**SUSQUEHANNA STEAM ELECTRIC STATION
REQUEST FOR ADDITIONAL INFORMATION (RAI) FOR THE
REVIEW OF THE SUSQUEHANNA STEAM ELECTRIC STATION
UNITS 1 AND 2, LICENSE RENEWAL APPLICATION (LRA)
SECTIONS 2.2, 2.3.3, 2.3.4
PLA-6276**

**Docket Nos. 50-387
and 50-388**

Enclosure: PPL Responses to Request for Additional Information (Sections 2.2, 2.3.3, 2.3.4)

LR-M-166-2

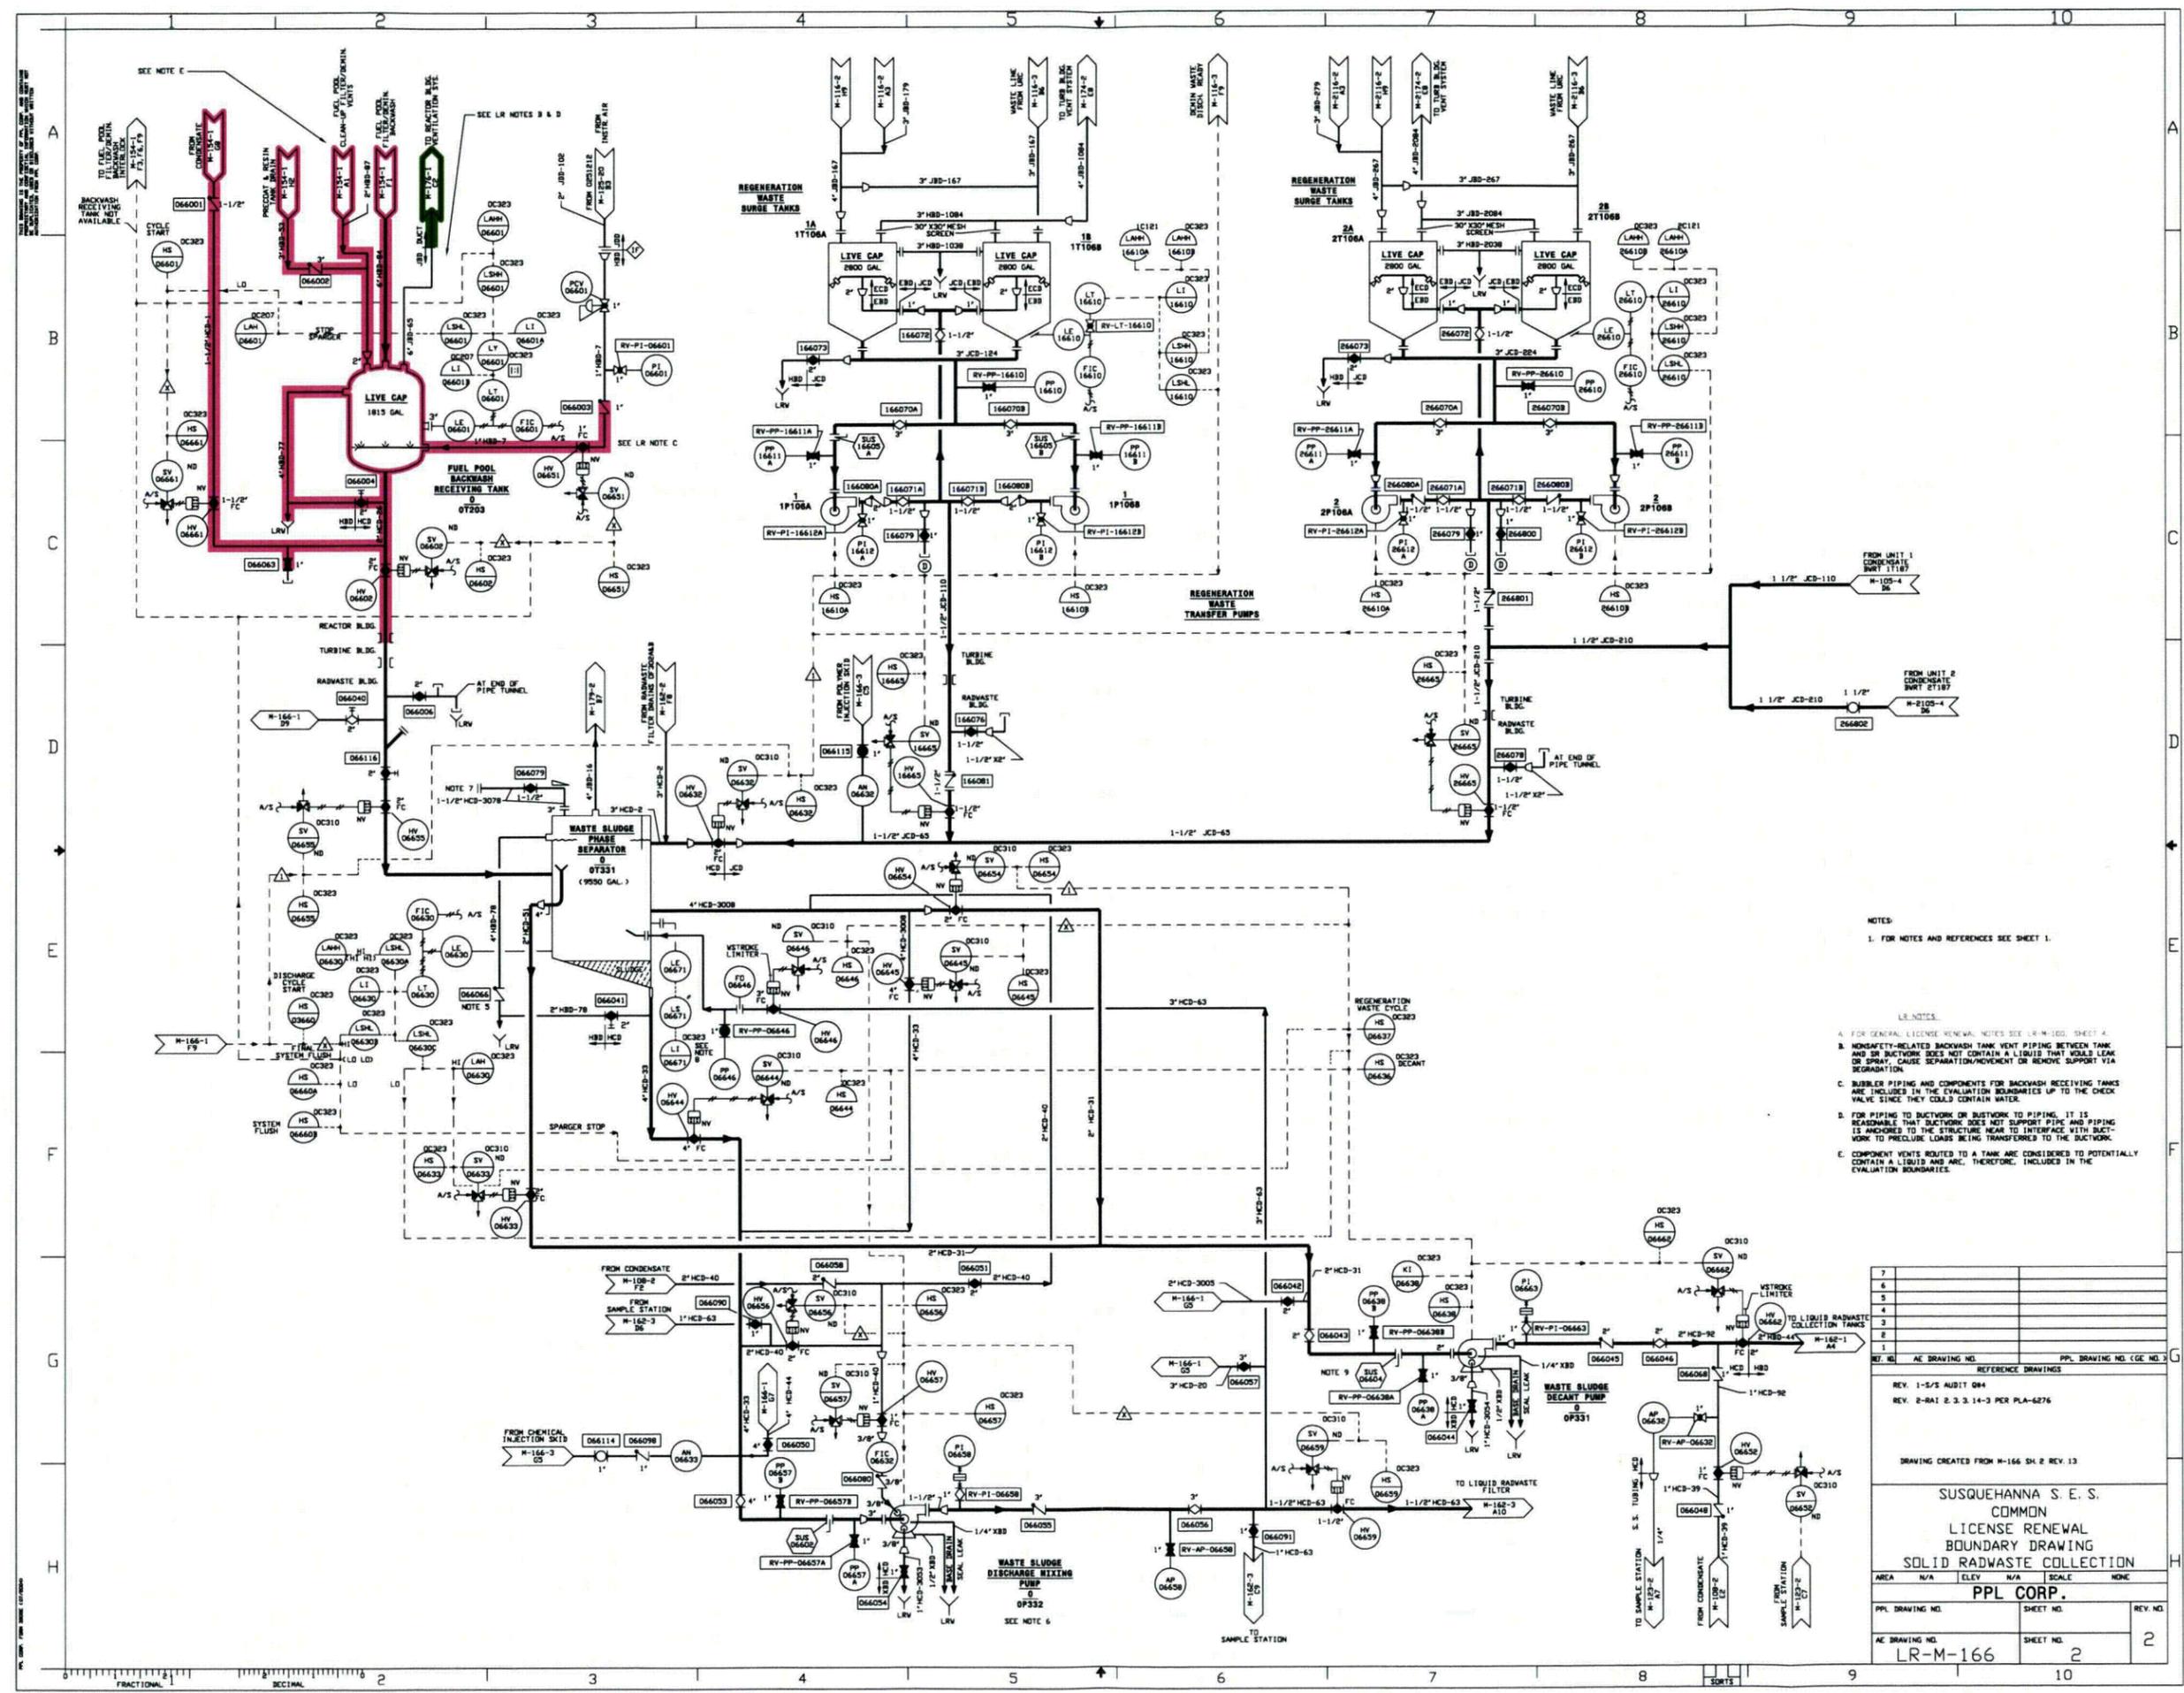
License renewal drawing LR-M-154-1, locations C3, C6, and C9, shows the boundary (based on 10 CFR 54.4(a)(2)) at the top of the fuel pool filter demineralizers. Though not within scope, two-inch vent pipes are shown that exit the top of the filter demineralizers and go to the vent header two-inch HBD-87 piping, which also is not within scope. License renewal drawing LR-M-154-1, location A1, shows a continuation from the out-of-scope vent header two-inch HBD-87 piping to drawing LR-M-166-2, location A2, where the two-inch HBD-87 piping is shown within the scope of license renewal. Provide additional information explaining why the two-inch vent piping and two-inch HBD-87 vent header piping are not within the scope of license renewal and justify the boundary locations with respect to the applicable requirements of 10 CFR 54.4(a).

License renewal Note E on drawing LR-M-166-2 states that component vents routed to a tank are considered to potentially contain a liquid and are included in the evaluation boundaries.

The vent piping from the fuel pool filter demineralizers on drawing LR-M-154-1 up to the vent header and continuing onto drawing LR-M-166-2 at location A2 and to the connection to the fuel pool backwash receiving tank is within the scope of license renewal per the criteria of 10 CFR 54.4(a)(2). The drawings are revised to highlight the piping as pink (magenta).

LR-M-186-1

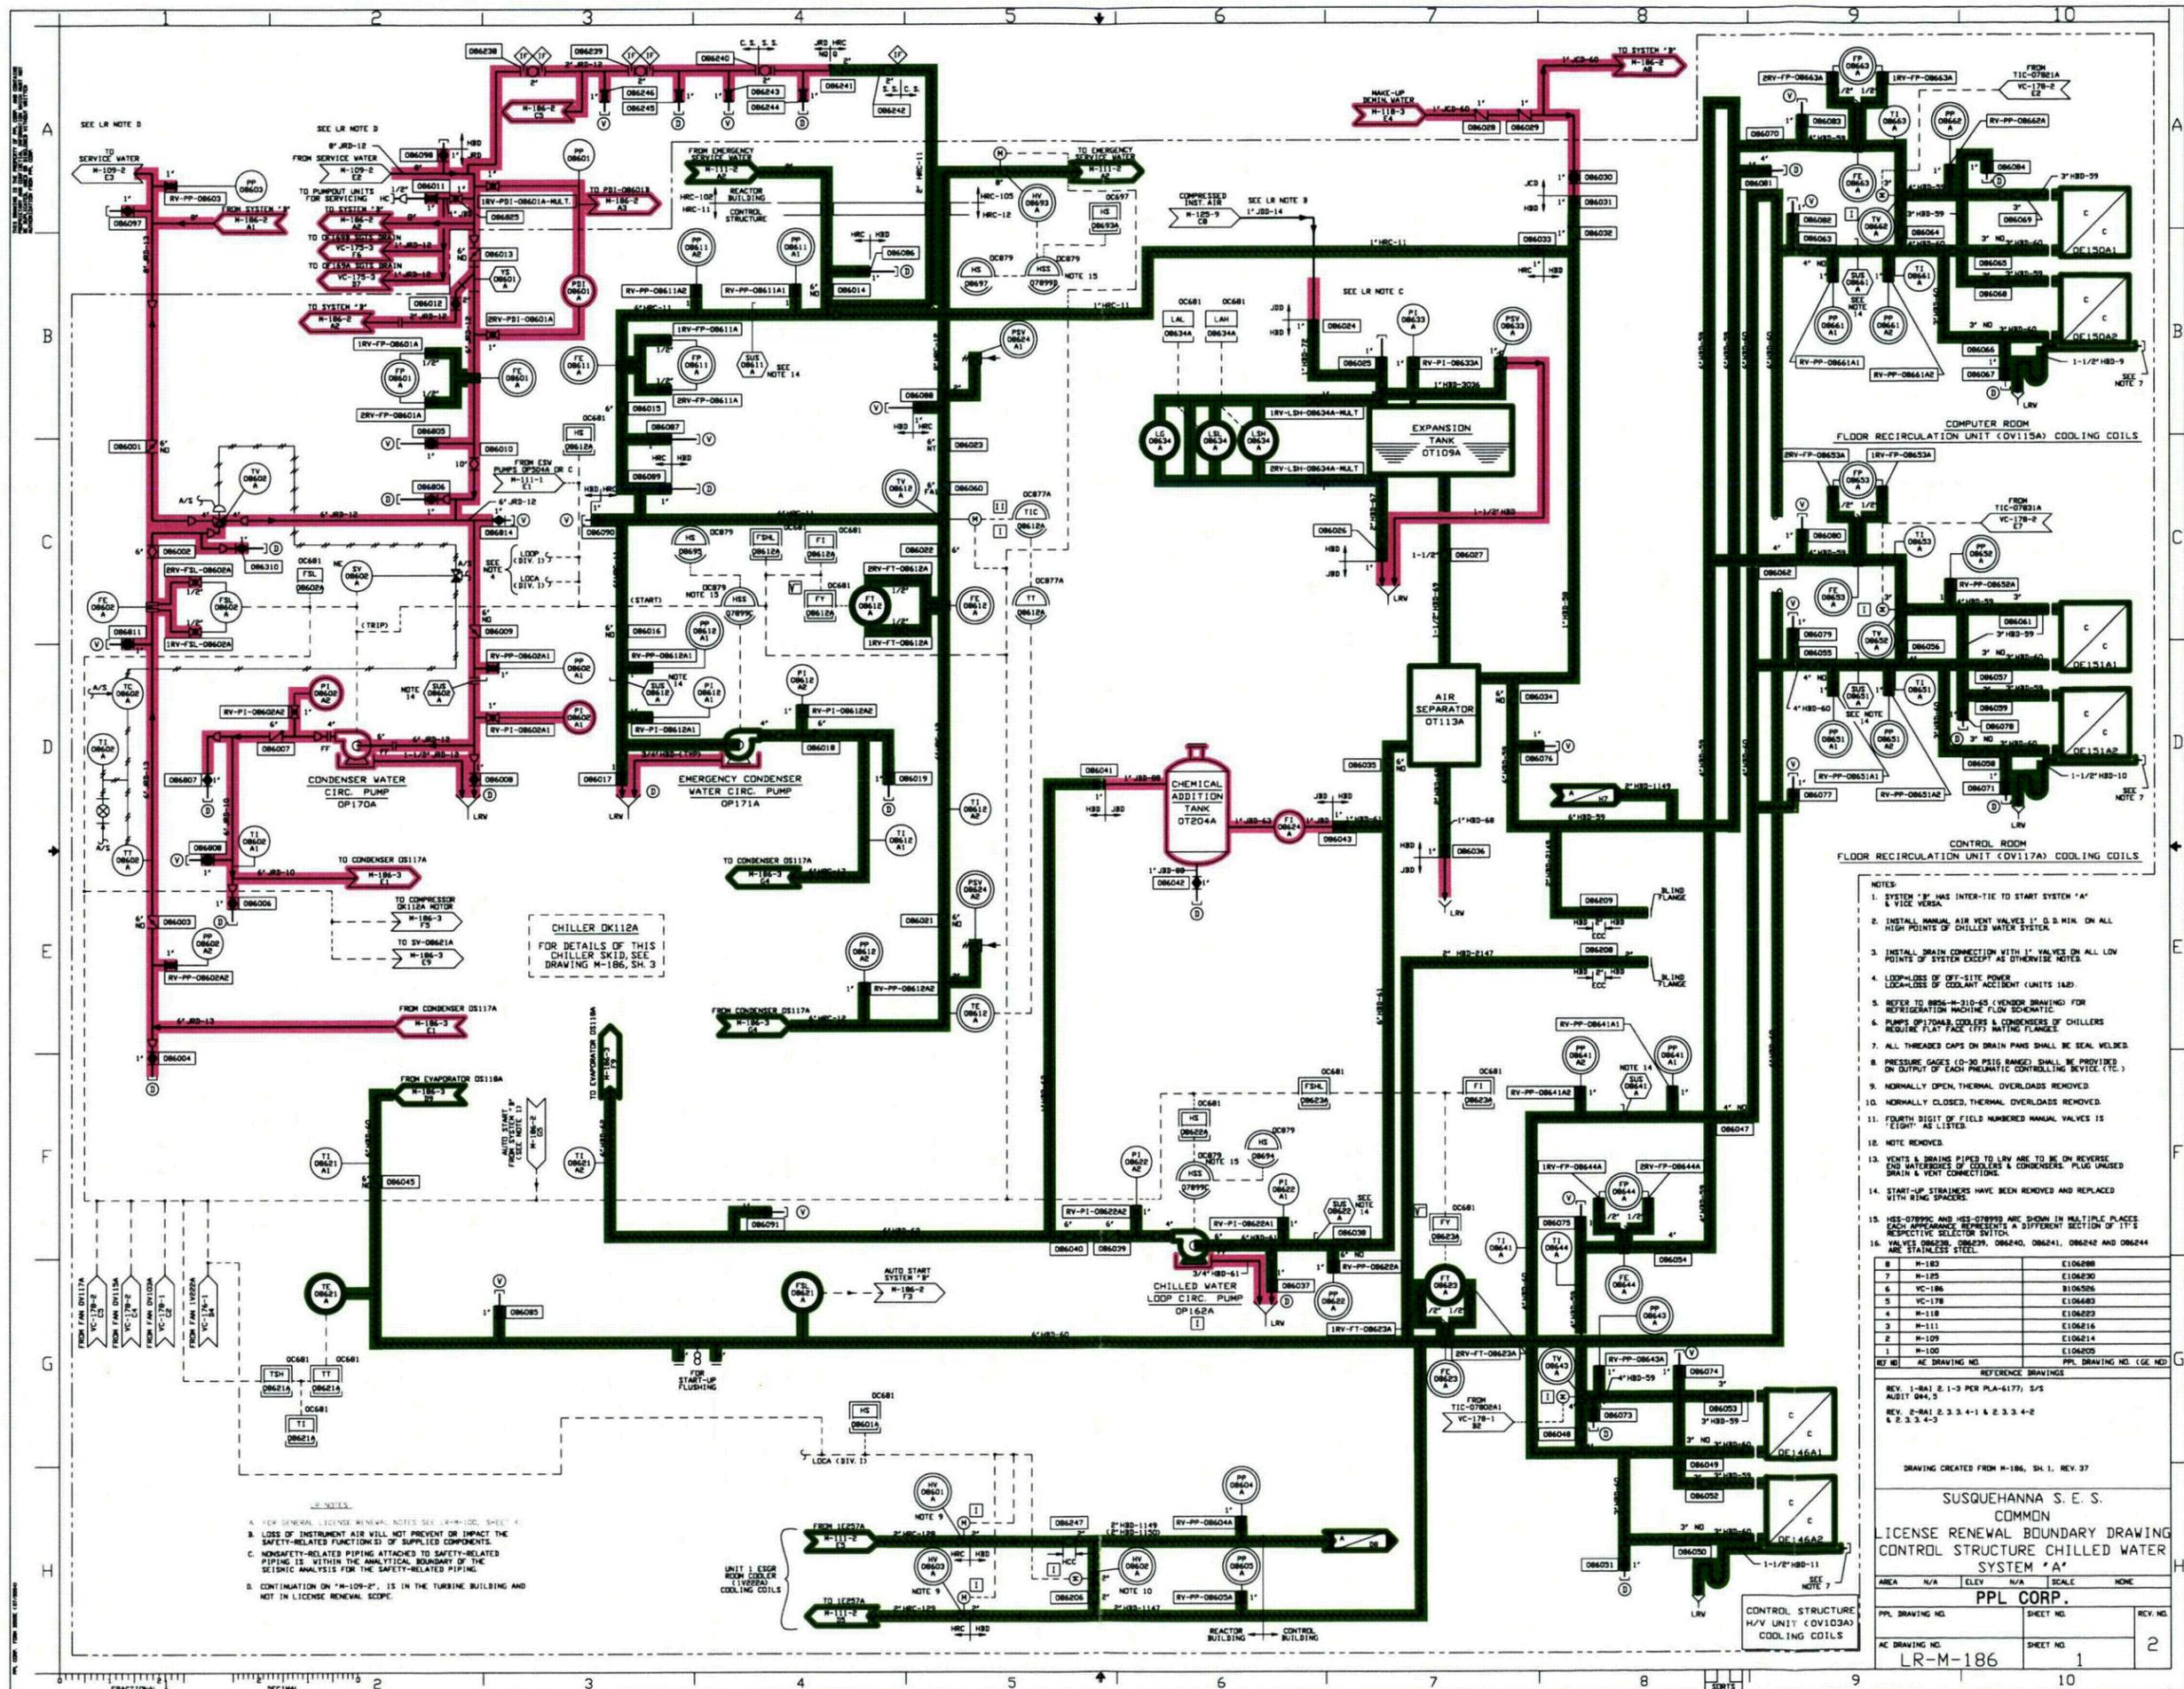
License renewal drawing LR-M-186-1, location A3, shows nonsafety-related piping that has the potential for spatial interaction with safety-related piping, based on criterion 10 CFR 54.4(a)(2) and it is continued on drawing LR-M-186-2, location C5 that is not within the scope of license renewal. Provide additional information on why the continuation on drawing LR-M-186-2 is not within the scope of license renewal and justify the boundary locations with respect to the applicable requirements of 10 CFR 54.4(a).

License renewal drawing LR-M-186-1, location A2, shows service water eight-inch JRD-12 piping within the scope of license renewal. The line is continued on drawing LR-M-109-2, location E2. The continuation on drawing LR-M-109-2, location E2 from drawing LR-M-186-1 does not indicate that the eight-inch JRD-12 piping is in scope and does not include a license renewal boundary. Provide additional information explaining why the eight-inch JRD-12 piping shown on LR-M-109-2 is not within the scope of license renewal and justify the boundary locations with respect to the applicable requirements of 10 CFR 54.4(a).

License renewal drawing LR-M-186-1, location A1, shows service water eight-inch JRD-13 piping within the scope of license renewal. The line is continued on drawing LR-M-109-2, location E3. The continuation on drawing LR-M-109-2, location E3 from drawing LR-M-186-1 does not indicate that the eight-inch JRD-13 piping is within scope and does not include a license renewal boundary. Provide additional information explaining why the eight-inch JRD-13 piping shown on drawing LR-M-109-2 is not within the scope of license renewal and justify the boundary locations with respect to the applicable requirements of 10 CFR 54.4(a).

The piping in question, 2" JRD-12 from the "T" on LR-M-186-1 through the continuation to LR-M-186-2 to valve 086341, is within the scope of license renewal for 10 CFR 54.4(a)(2) through spatial interaction and because it supports the safety-related functional boundary of the system. The entire pipeline from the 2" JRD-12 "T" on LR-M-186-1 to the HRC/JRD interface at valve 086341 on LR-M-186-2 has been highlighted pink (magenta). LRA changes are not required as the equipment covered by the additional highlighting is included in the existing LRA component/material/environment combinations.

DRAWING	CONDITION	CHANGE
LR-M-186-1	2" JRD-12 at A3 is not highlighted. The pipe is within the scope of license renewal for (a)(2).	Highlight pink (magenta) 2" JRD-12 at A3 to the continuation arrow to "M-186-2 C5".
LR-M-186-2	2" JRD-12 at C4 is not highlighted. The pipe is within the scope of license renewal for (a)(2).	Complete highlighting pink (magenta) 2" JRD-12 from the continuation arrow at C5.

As discussed in LRA Section 2.3.3.31, portions of the Service Water System meet the scoping criteria of 10 CFR 54.4(a)(2) and are therefore in LRA scope and subject to AMR. Based on the "spaces" approach discussed in LRA Section 2.1.1.2.2, the portion of 8" JRD-12 shown on LR-M-186-1 at A2 is located within the control structure and thus is in LRA scope. The portion shown on LR-M-109-2 is in the turbine building and is not in LRA scope. Neither boundary drawing LR-M-186-1 nor LR-M-109-2, depicts the boundary between the two buildings. Therefore, in clarification the highlighting of just the continuation arrow on LR-M-186-1 at A2 "from M-109-2 E2" has been deleted to more clearly show that the portion of 8" JRD-12 on LR-M-186-1, is within the control structure and is in scope and subject to AMR, but the portion continued on LR-M-109-2 is in the turbine building and is not in LRA scope.

DRAWING	CONDITION	CHANGE
LR-M-186-1	The continuation arrow to 8" JRD-12 at A2 from "M-109-2 E2" is highlighted, but the corresponding continuation arrow on LR-M-109-2 is not. The pipe in the control structure is within the scope of license renewal for (a)(2).	Delete the pink (magenta) of continuation arrow for 8" JRD-12 at A2. Add an LR note to show only the pipe in the control structure is within the scope of license renewal.

As discussed in LRA Section 2.3.3.31, portions of the Service Water System meet the scoping criteria of 10 CFR 54.4(a)(2) and are therefore in LRA scope and subject to AMR. Based on the "spaces" approach discussed in LRA Section 2.1.1.2.2, the portion of 8" JRD-12 shown on LR-M-186-1 at A2 is located within the control structure and thus is in LRA scope. The portion shown on LR-M-109-2 is in the turbine building and is not in LRA scope. Neither boundary drawing LR-M-186-1 nor LR-M-109-2, depicts the boundary between the two buildings. Therefore, the highlighting on the continuation arrow on LR-M-186-1 at A1 to "M-109-2 E3" has been deleted to more clearly show that the portion of 8" JRD-13 on LR-M-186-1 is within the control structure and is in scope and subject to AMR, but the portion continued from LR-M-109-2 is in the turbine building and is not in LRA scope.

DRAWING	CONDITION	CHANGE
LR-M-186-1	The continuation arrow to 8" JRD-13 at A1 to "M-109-2 E3" is highlighted, but the corresponding continuation arrow on LR-M-109-2 is not. The pipe in the control structure is within the scope of license renewal for (a)(2).	Delete the pink (magenta) of continuation arrow for 8" JRD-13 at A1. Add an LR note to show only the pipe in the control structure is within the scope of license renewal.
